**BRODIE CONSULTING LTD. - GIANT MINE CLOSURE COST ESTIMATE REPORT**

**REPORT ON**  
**GIANT MINE**  
**CLOSURE COST ESTIMATE**

November 27, 1997

**RE: GIANT MINE CLOSURE COST ESTIMATE**

Figure 1

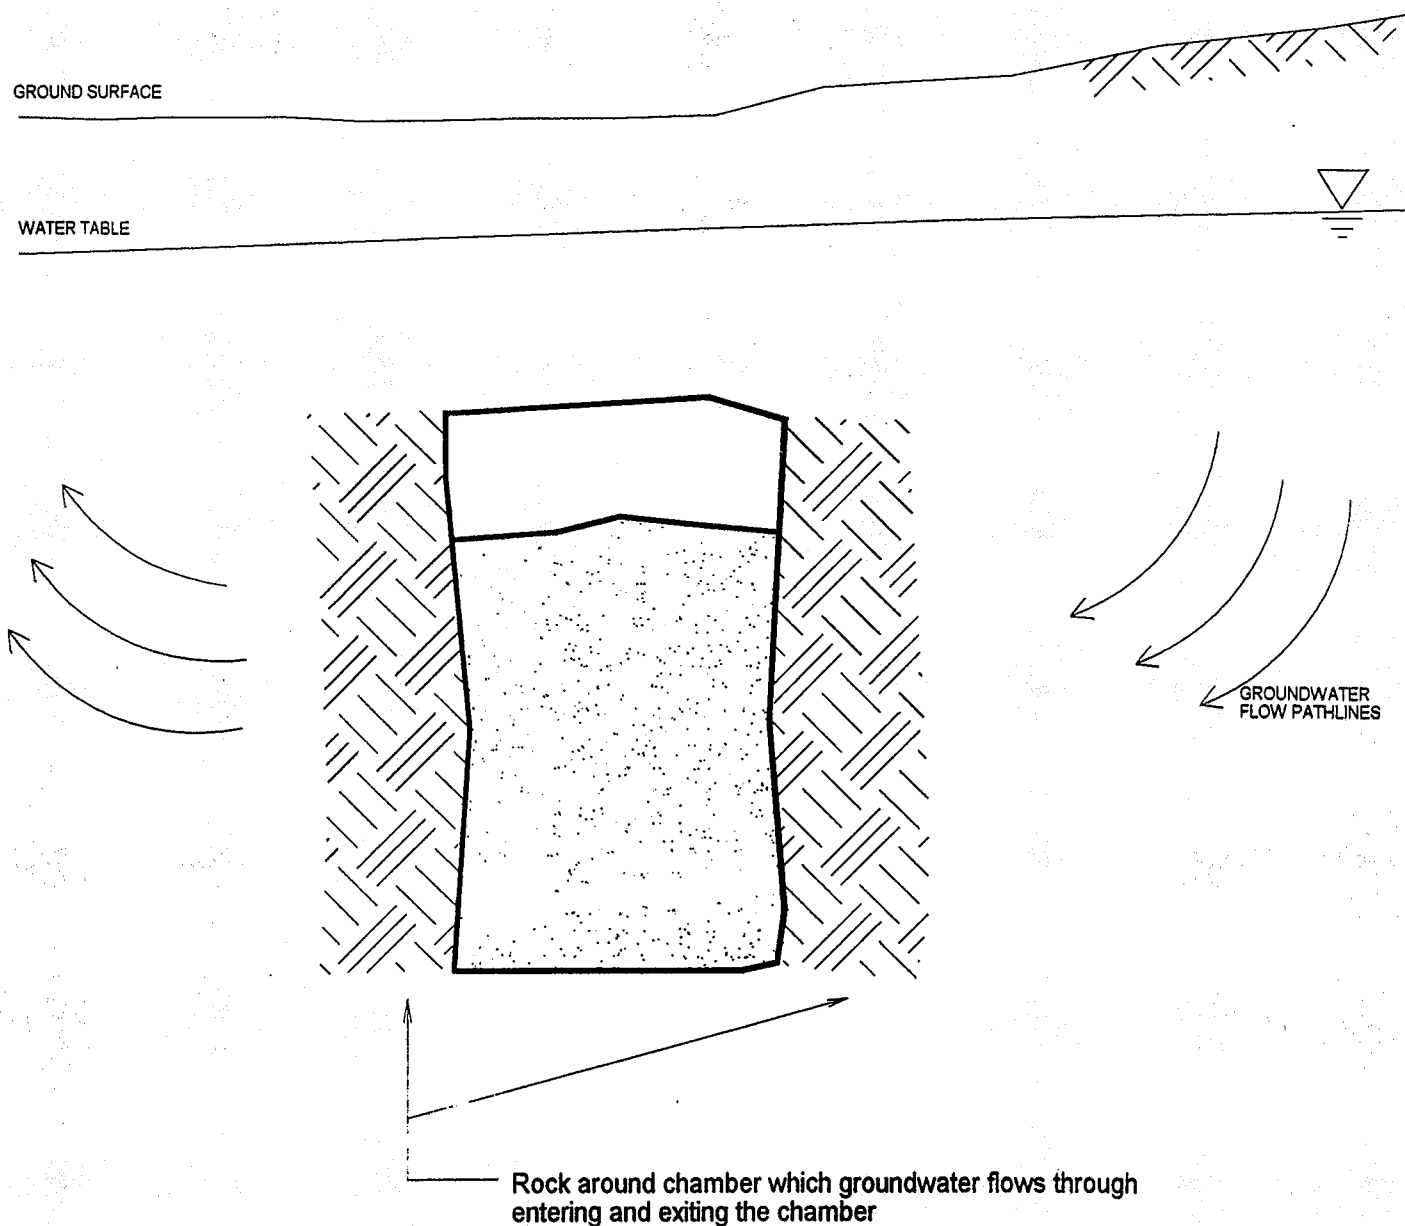
- We can roughly estimate the hydraulic conductivity of the rock around the chambers required to achieve this low level of seepage as illustrated in Figure 1 and as follows; assume the hydraulic gradient into the chambers is 0.05 (1 m head loss in 20 m, which is less than topographic slopes), assume the cross-section area of the chambers is 46 m high by a cumulative length of 533 m, using the formula  $Q = -k \times i \times A$  ( $Q$  = flow,  $-k$  = hydraulic conductivity,  $i$  = hydraulic gradient, and  $A$  = cross section area through which the flow passes), we find that the hydraulic conductivity of the rock and bulkheads around the arsenic trioxide would have to be  $1.35 \times 10^{-11} \text{ m/s}$ ,

Figure 2

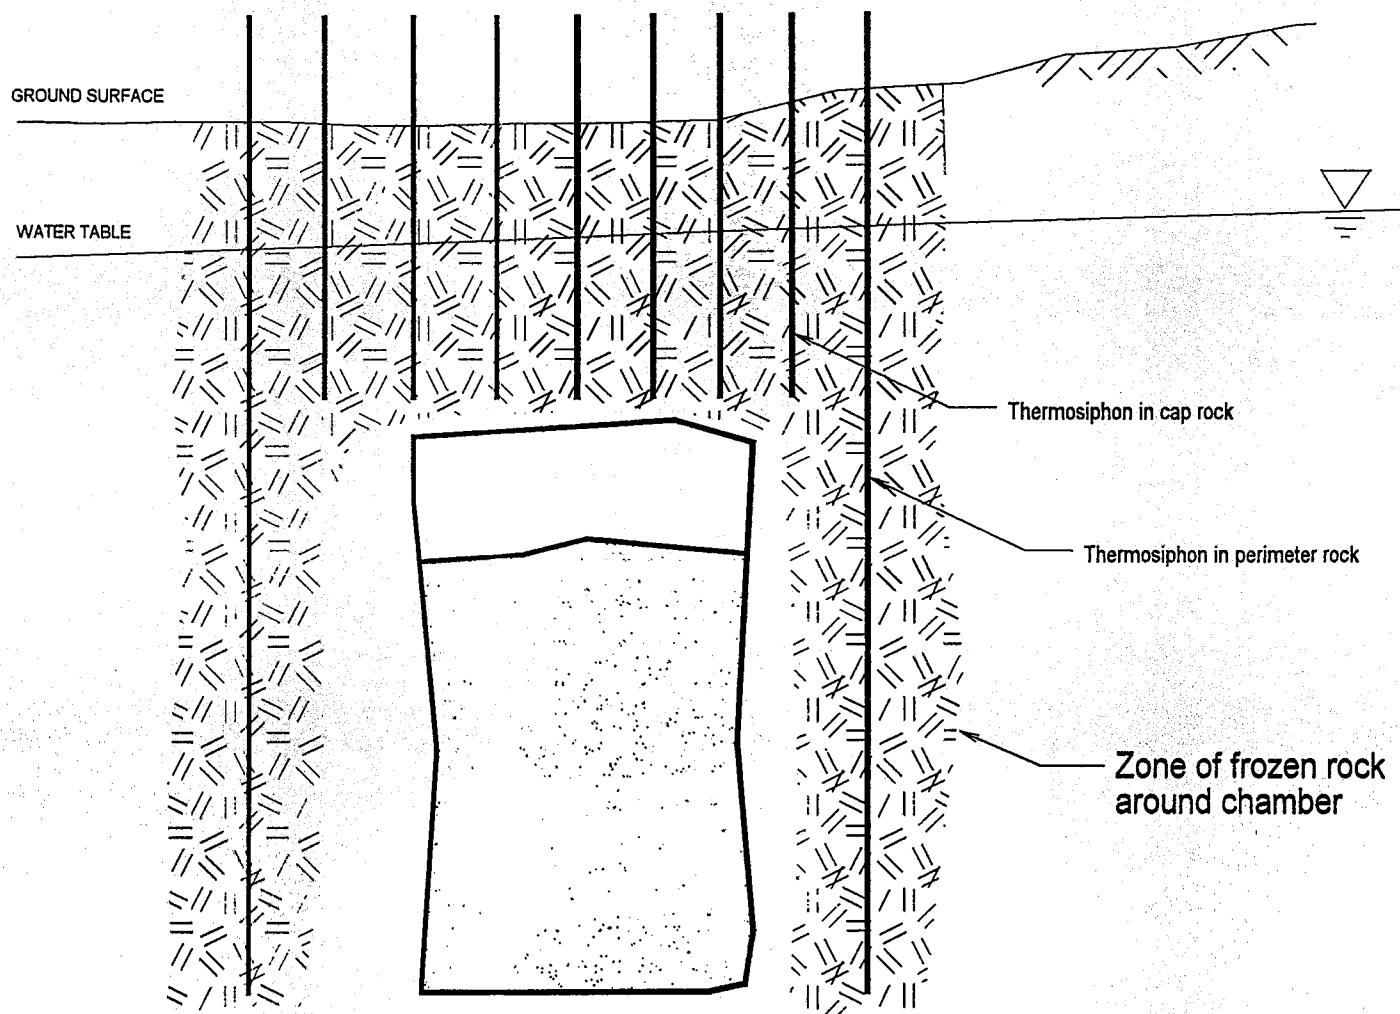
- Thermosiphons could be used to create a frozen perimeter around the chambers and in the ground above them. In this approach, flooding of the chambers would be allowed but release of arsenic would be prevented by a barrier of ice above and around the chambers. Movement of arsenic by dispersion through the unfrozen ground below the chambers would occur, however this process would be extremely slow. This concept is illustrated in Figure 2.
